**ADDENDUM
NO. 2**

August 23, 2021

**SCHOOL CITY OF HAMMOND -
2021 RENOVATIONS TO MORTON HIGH SCHOOL
AND SCOTT MIDDLE SCHOOL
Hammond, IN 46320**

EP101

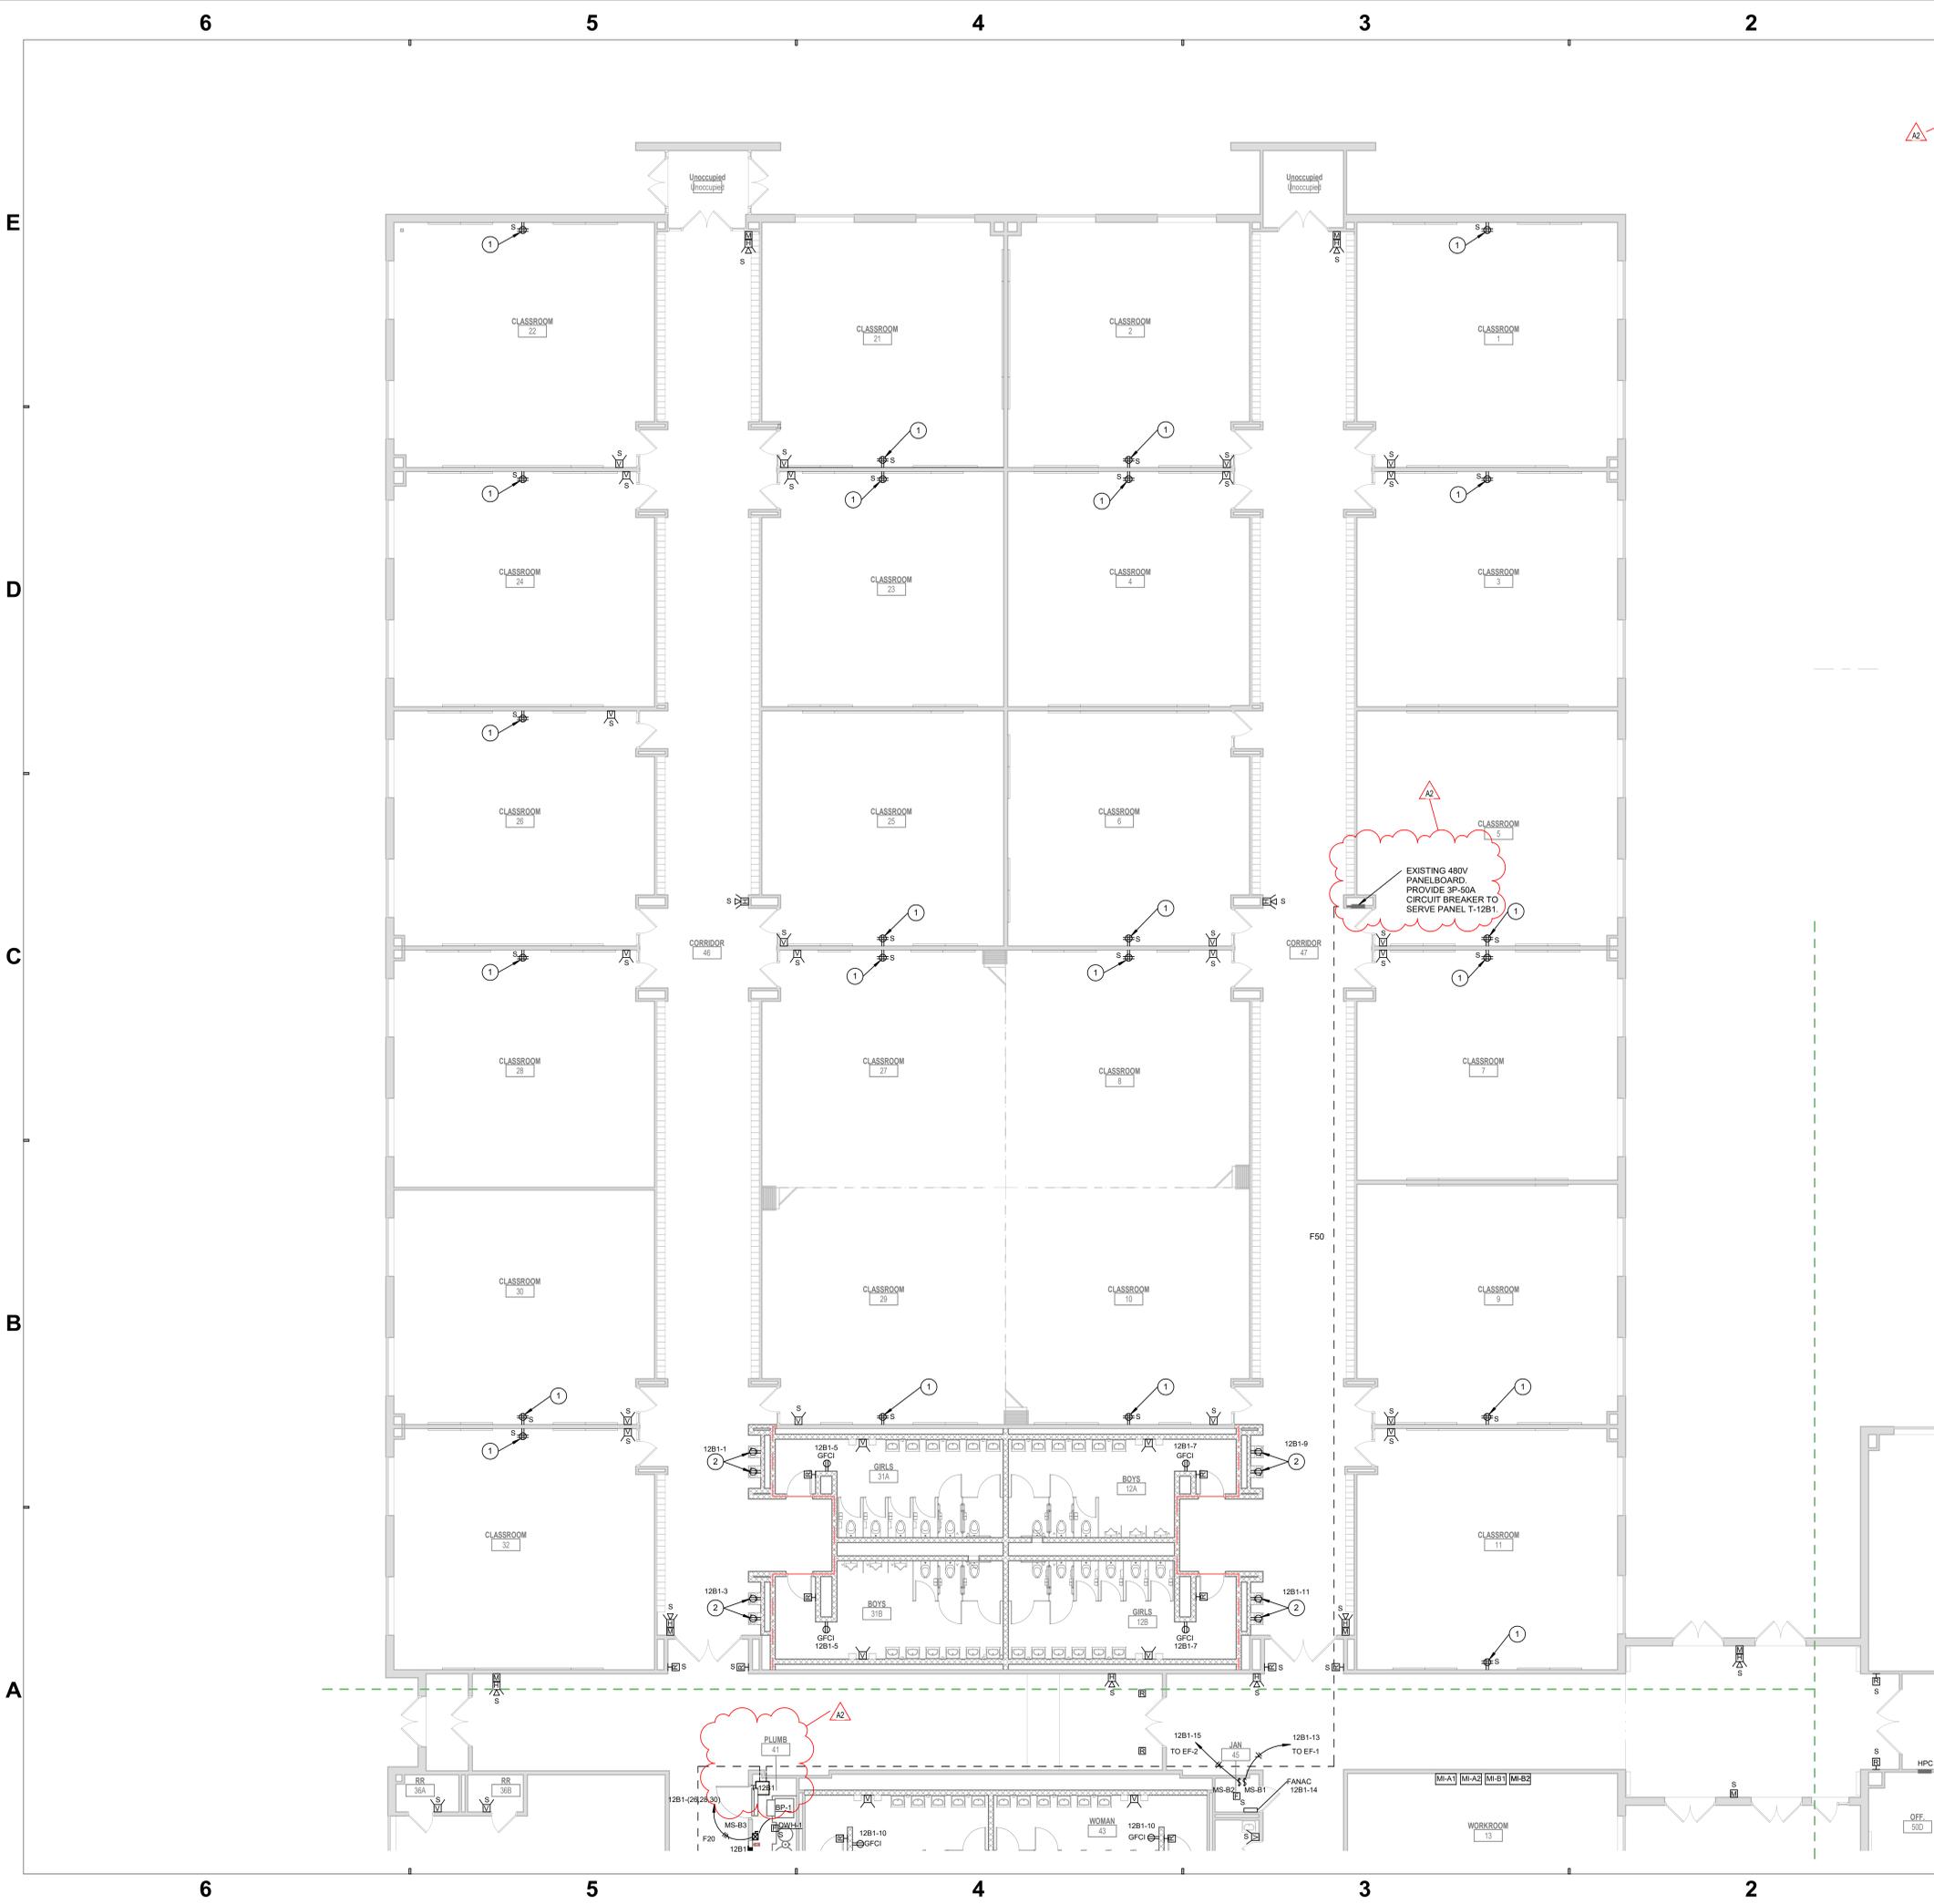
1. MODIFY Drawing EP1C1 as follows:
On south wall of office 52A adjacent to FAAP, add quadraplex receptacle at 48” A.F.F. to
CL to serve new intercom rack equipment. Coordinate with T-Series drawings.
